MORIN BUILDING
8570 EXECUTIVE PARK AVENUE
FAIRFAX, VIRGINIA 22116-0815

Subject: Addendum # 2 to IFB #18-53, Lee Highway Transmission Main

**IFB No. 18-53
PROJECT 2545, DIVISION 2
LEE HIGHWAY TRANSMISSION MAIN**

11

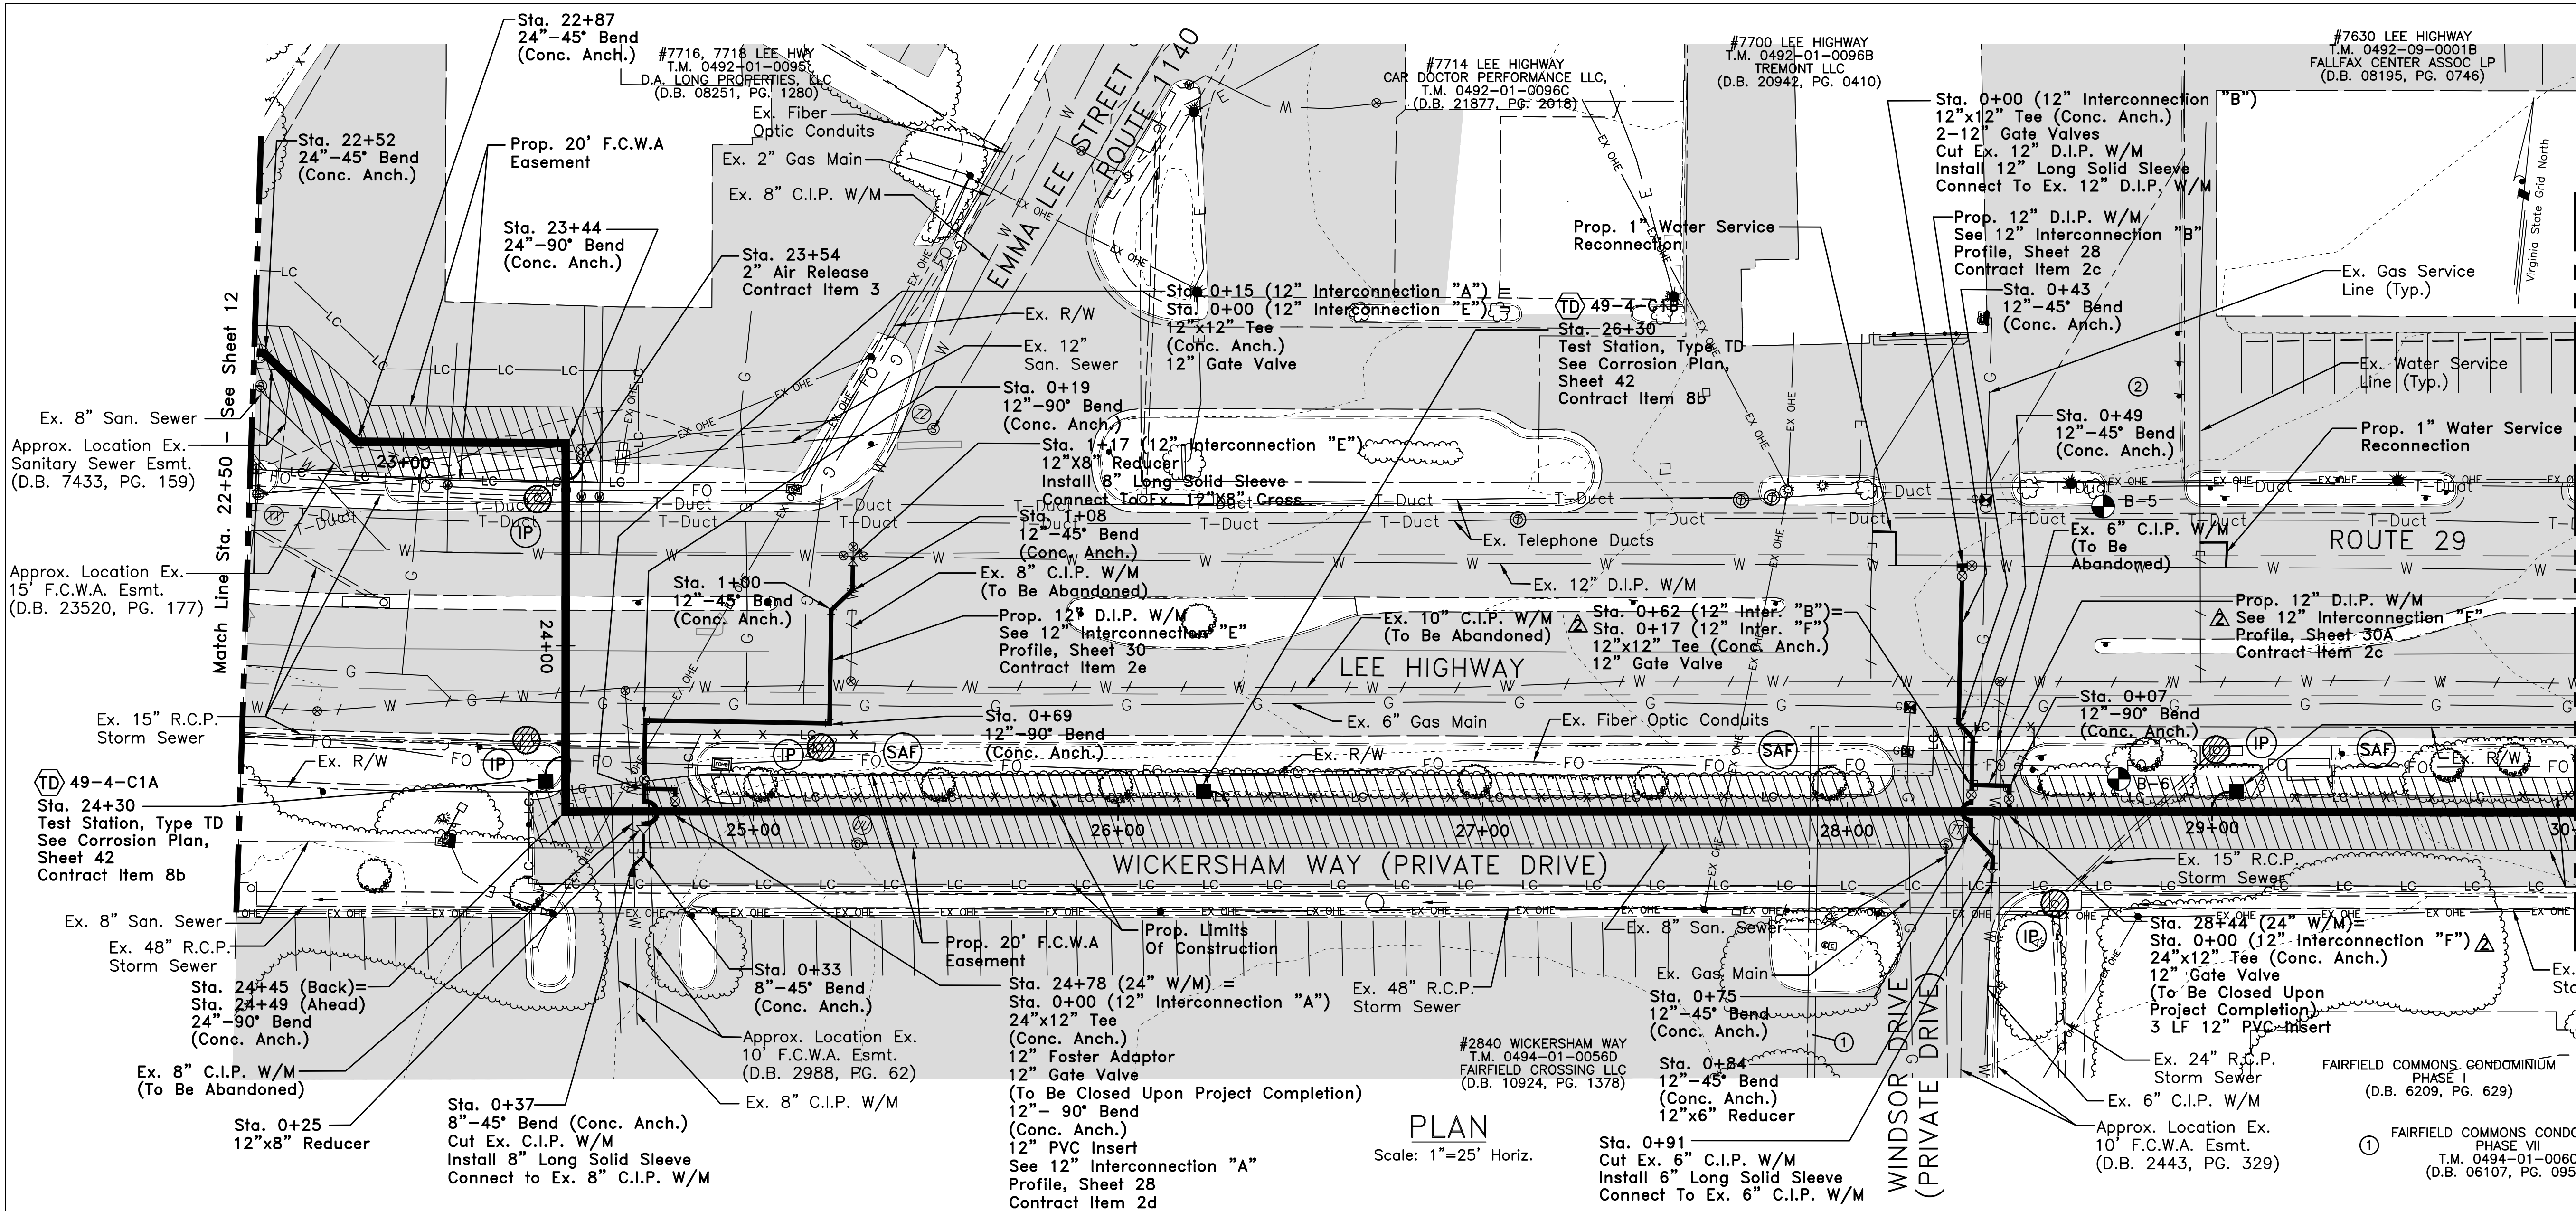
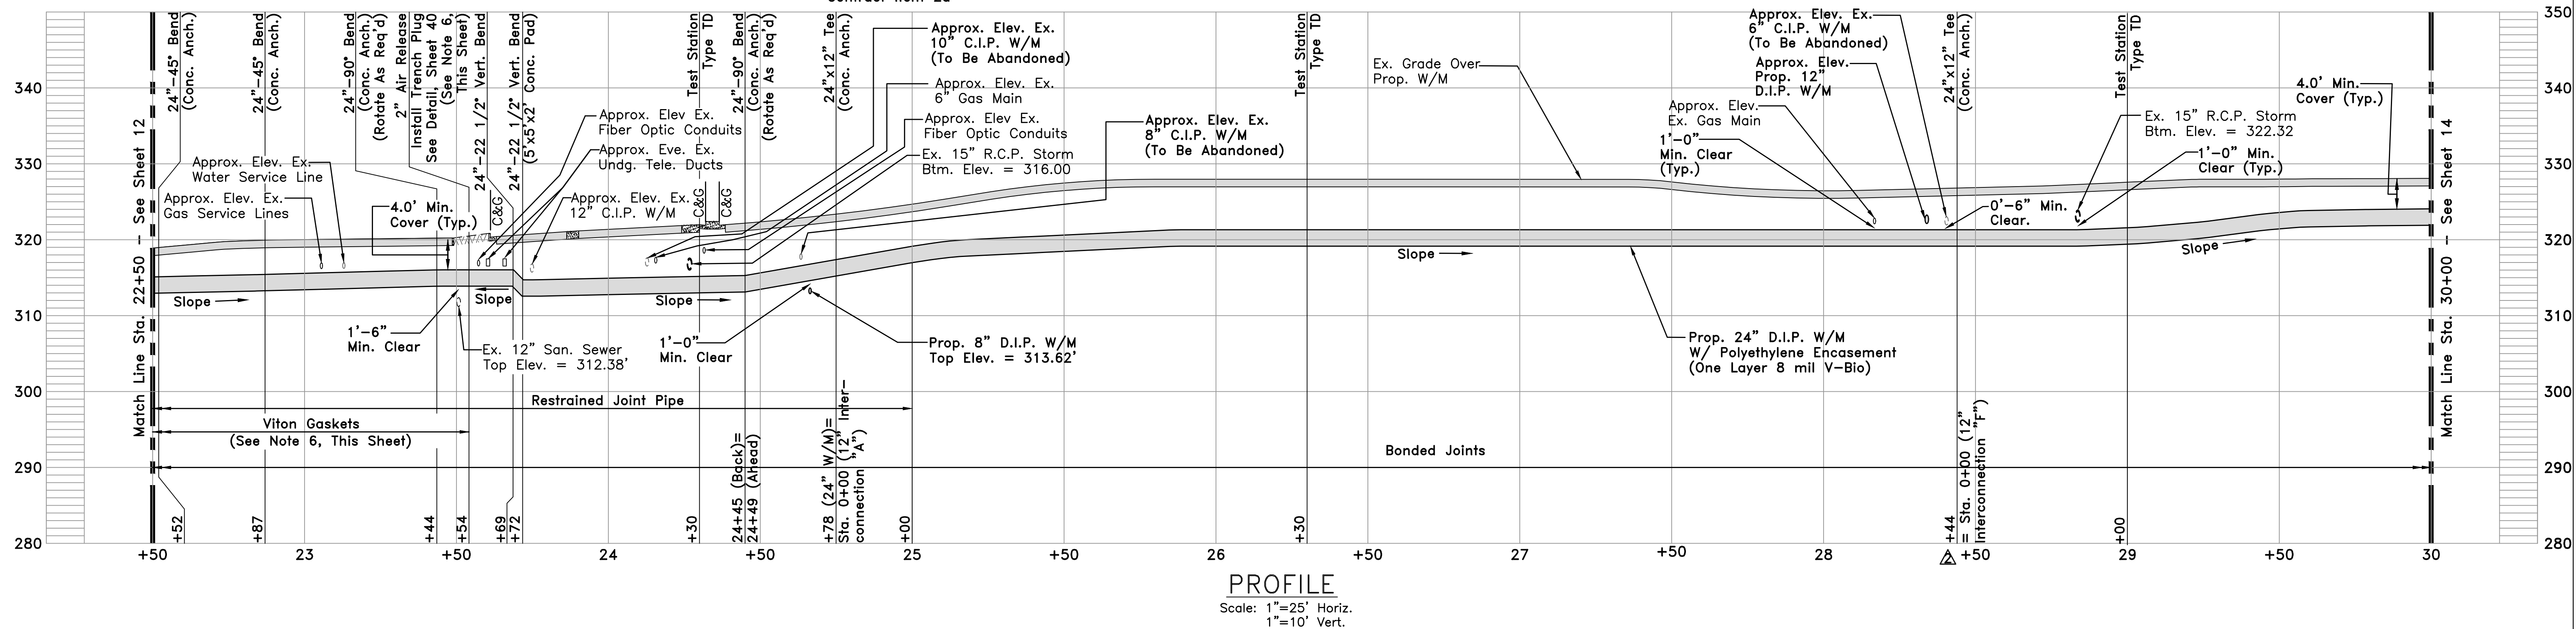
ADDENDUM NO. 2 - ADDED EX. VAULT
DIMENSIONS
